Proposed Rex Minerals Mining Lease Proposal for Hillside

HILLSIDE MINING LEASE PROPOSAL AND MANAGEMENT PLAN: A RESPONSE

**Yorke Peninsula Land Owners' Group
8th November 2013**

Figure B.5.4: Predicted maximum 24-hour PM₁₀ Concentration (Mine Operations) – including background concentration

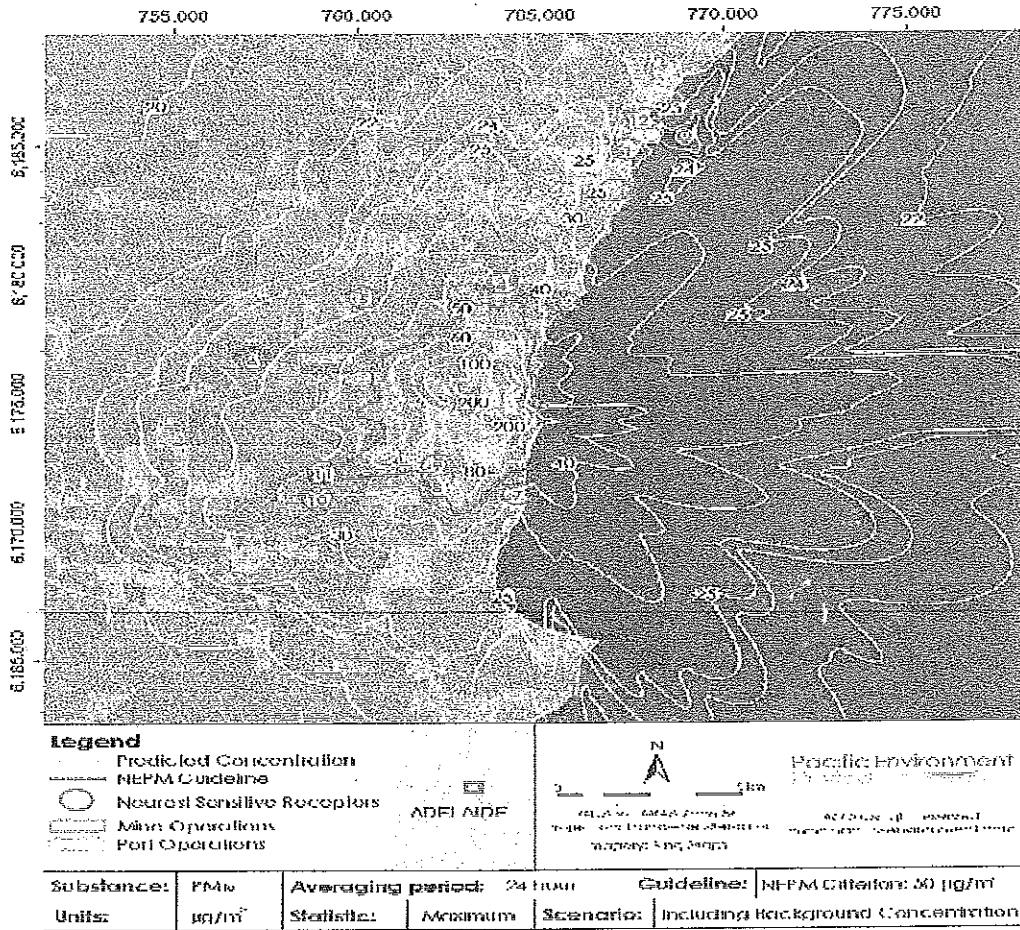
- Rex Minerals' Dust Predictive Map (Figure B5.4, based on full production for all days with no limitations on operations, and all 'so-called' dust controls applied shows maximum levels of dust that would be experienced in a 24 hour period. As shown, PM₁₀ emissions extend from the north of Ardrossan township, covering a wide area to the south of Black Point, moving inland and also extending well into the Gulf, raising issues of sea water contamination from dust settling on the surface of the water.

These predictions seem highly questionable given that baseline data found that NEPM air quality standards were exceeded on 6 occasions during 2012 as a result of strong northerly winds. And these high levels occurred without the 1.4 million tons of dust that the mining operation will generate.

Given this huge amount of additional dust generated by the mine, it is highly unlikely that there will be only three days of 'extreme climatic conditions'. Yorke Peninsula has far more than only three or six windy days per year as evidenced by the winds that have buffeted the region in the last month or so.

How much more PM10 dust will there be compared with pre-mining levels?

- **How much more dust (especially PM10) will local communities (notably Pine Point, Rogues Point, James Well and Black Point) as well as surrounding farms actually experience compared with the baseline situation? More specifically:**
- **On how many days will PM10 concentrations approach or actually reach the maximum 24 hour levels depicted in Figure 8.5.4?**
- **On how many days will increased levels (compared with pre-mining days) be experienced?**
- **What is the average level of PM10 concentrations that we can expect?**
- **On how many days will that average be exceeded?**
